CHILDREN'S HOSPITAL  
OF ORANGE COUNTY  
455 S. Main St.  
Orange, CA 92668-3874

TOWER II

LEVEL 3 ENLARGED PLAN  
AREA - F

A3.3F

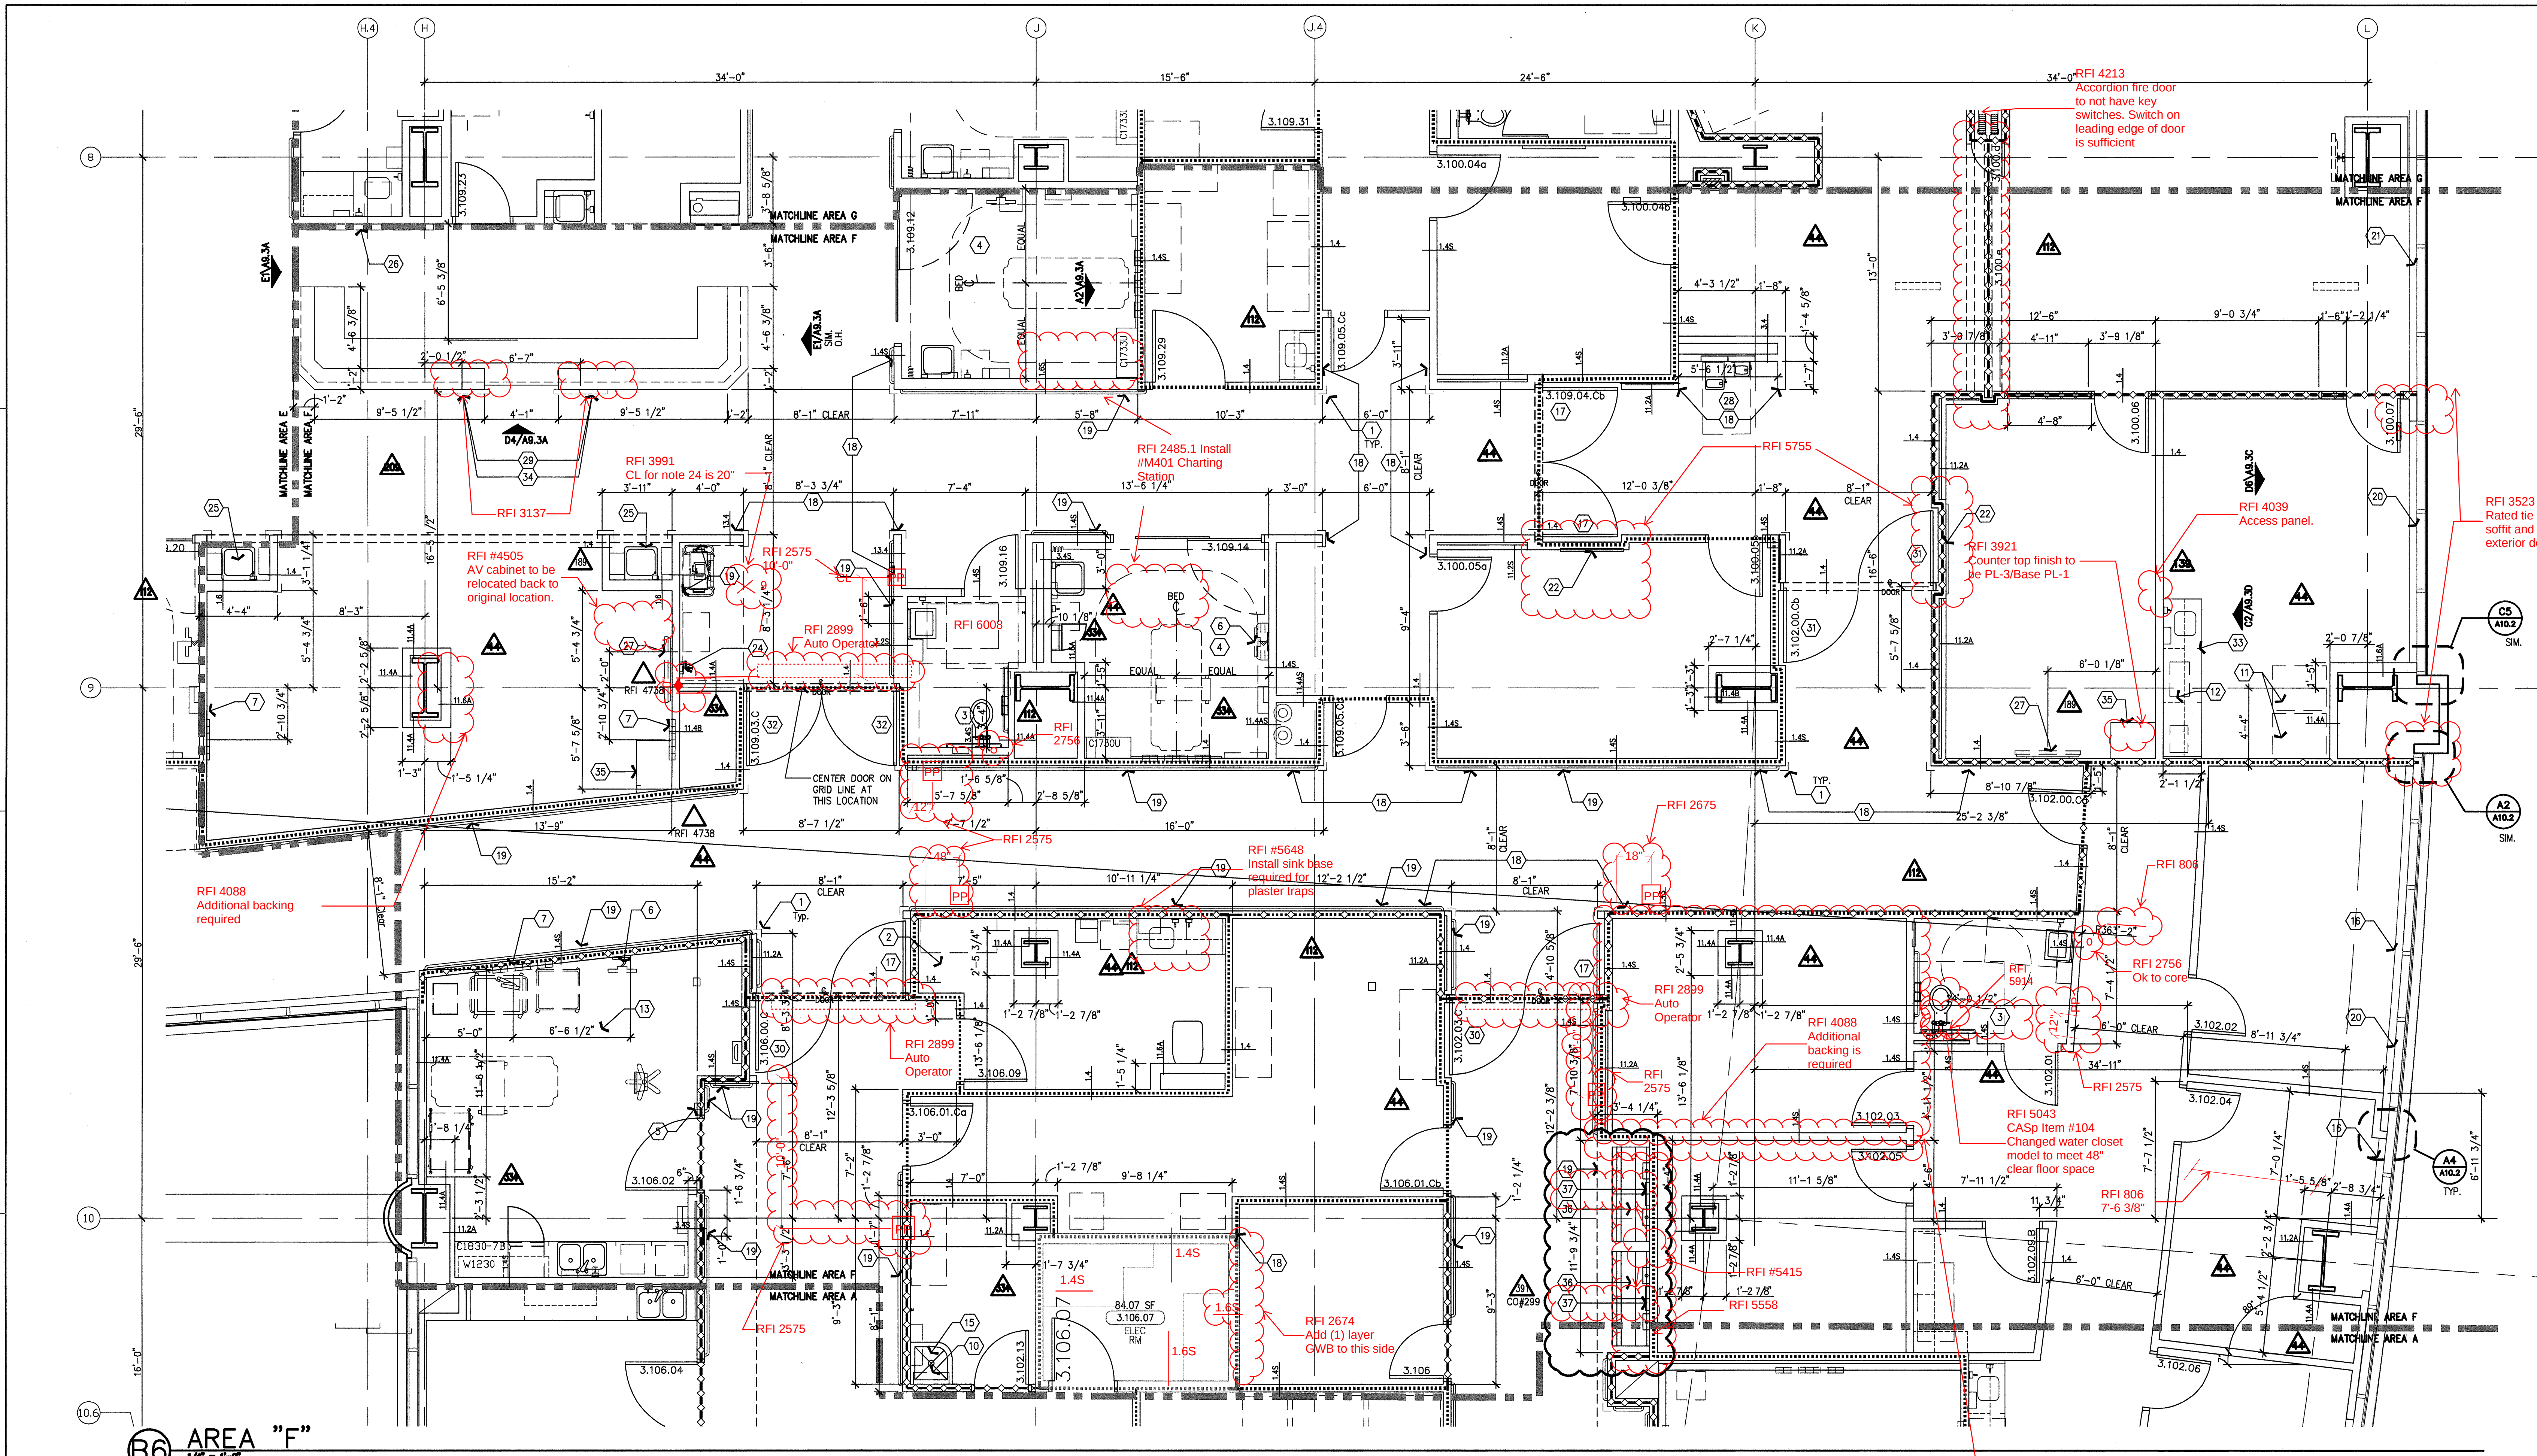
RFI 1213  
Dimensions for intersections  
of radius wall

RFI 4094  
See detail for  
additional bracing
